192nd session

Proposal for a Supplement 10 to the 03 series of amendments to UN Regulation No. 79 (Steering equipment)

Submitted by the Working Party on Automated/Autonomous and Connected Vehicles*

Model A

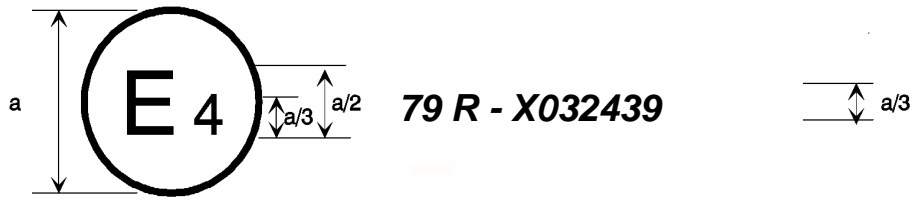
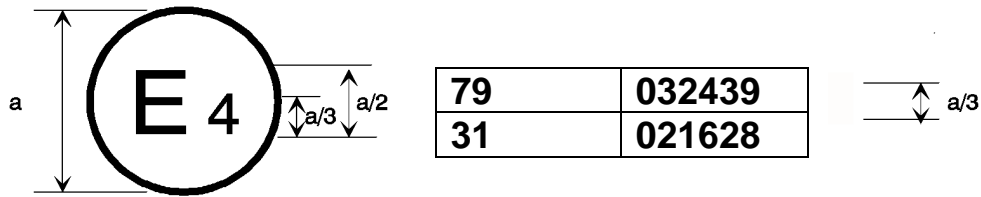
Annex 2, amend to read with square brackets amended as appropriate :

The above approval mark affixed to a vehicle shows that the vehicle type concerned has, with regard to steering equipment, been approved in the Netherlands (E 4) pursuant to UN Regulation No. 79 under approval No. 032439. The letter “X” preceding the approval number indicates that the vehicle is equipped with ACSF which has been exempted from the requirements of this UN Regulation, and/or that the vehicle is equipped with a steering system which exhibits functionality defined as an ACSF of Category D. The approval number indicates that the approval was granted in accordance with the requirements of UN Regulation No. 79 incorporating the 03 series of amendments.”

Model B
(See paragraph 4.5. of this Regulation)

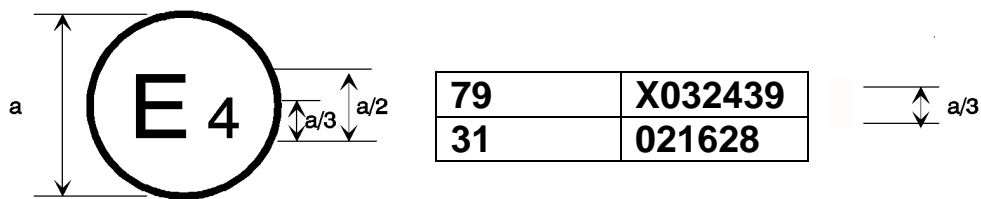
The above approval mark affixed to a vehicle shows that the vehicle type concerned has been approved in the Netherlands (E 4) pursuant to Regulations Nos. 79 and 31.⁴ The letter “X” preceding the approval number pursuant to Regulation No. 79 indicates that the vehicle is equipped with ACSF which have been exempted from the requirements of this UN Regulation, or that the vehicle is equipped with a steering system which exhibits functionality defined as an ACSF of Category D. The approval numbers indicate that, at the dates when
